File Code: 2720; 1900
Date: July 30, 2015

The Forest Service appreciates the opportunity to review the draft resource reports filed by Atlantic Coast Pipeline, LLC for the proposed Atlantic Coast Pipeline Project (Docket No. PF15-6-000). The proposed project would affect National Forest System (NFS) lands on the George Washington National Forest and the Monongahela National Forest.

**Comments of the U.S. Forest Service
Atlantic Coast Pipeline Project No. PF15-6-000
Draft Resource Reports**

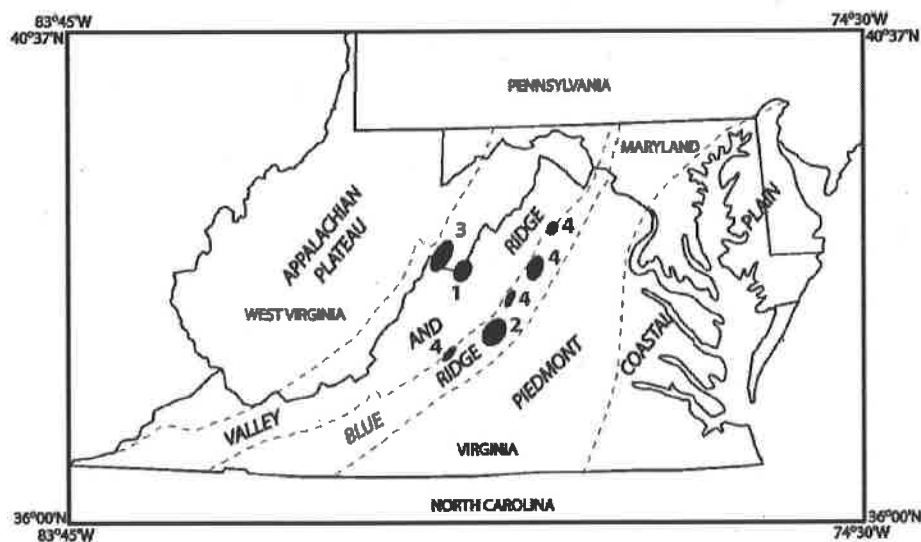
155. Consider the frequency of debris flow events, including the major debris flow events in Virginia and West Virginia from 1949 to 1996 (Figure 1). Recognize that the ACP project is in the vicinity of these major debris flow events in Virginia and West Virginia from 1949 to 1996, and assess the potential for future debris flows events to occur on the part of the ACP project on the GWNF and MNF. Recognize that intense storms can occur in any hurricane season as well as outside the hurricane season.

Figure 2. Old Coal Mine/Strip Workings on the Monongahela National Forest.

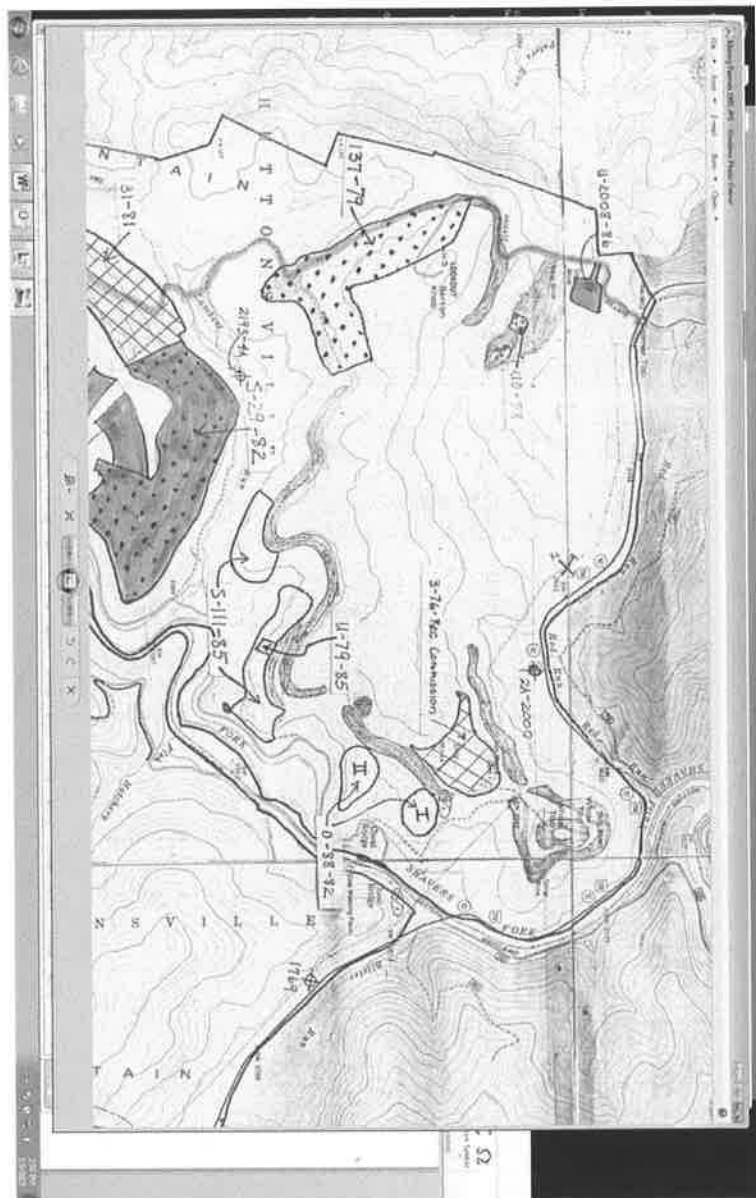
159. The map shown in Figure 2 illustrates the known locations of areas impacted by former mines and provides the history of the area that should be considered when collecting data, identifying effects, and conducting the analysis.

Figure 3. Role of debris flows in long-term landscape denudation in the central Appalachians of Virginia (Eaton et al. 2003).

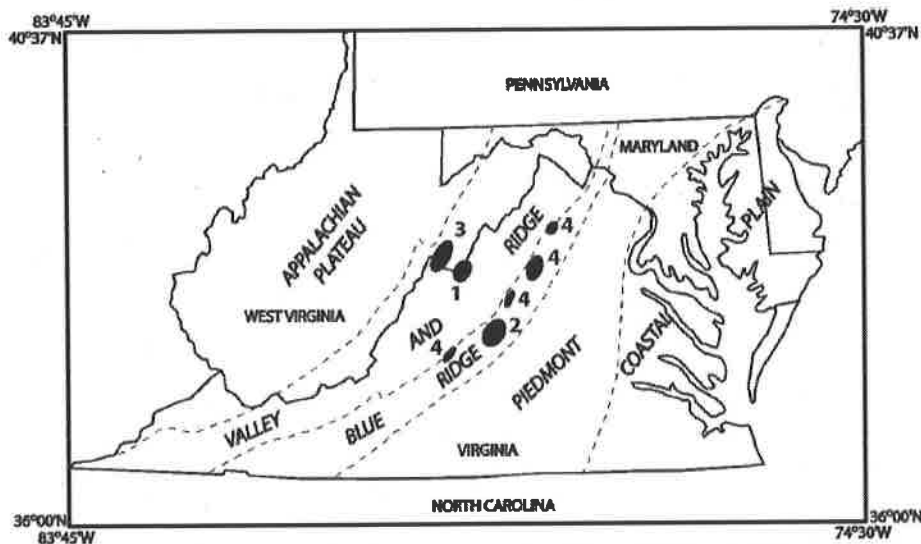
181. Assess the potential for debris flow type of landslides to impact the pipeline and associated facilities on GWNF and MNF. Consider the frequency of debris flow events, including the major debris flow events in Virginia and West Virginia from 1949 to 1996 (see Figure 3).

Figure 5. Debris flows in Davis Creek area triggered by remnants of Hurricane Camille August 19/20, 1969 in Nelson County, Virginia (Morgan et al. 1999).

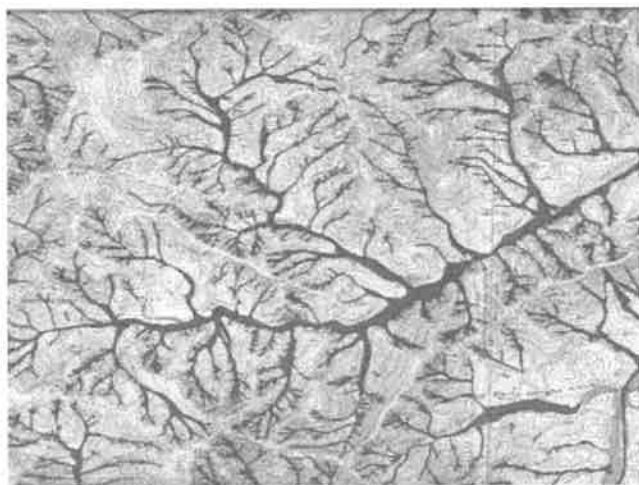
182. Assess the potential impacts on pipeline and access roads of swarms of debris flows, such as occurred in June 1949 in Augusta County (Figure 4) and in August 1969 in Nelson County (Figure 5).
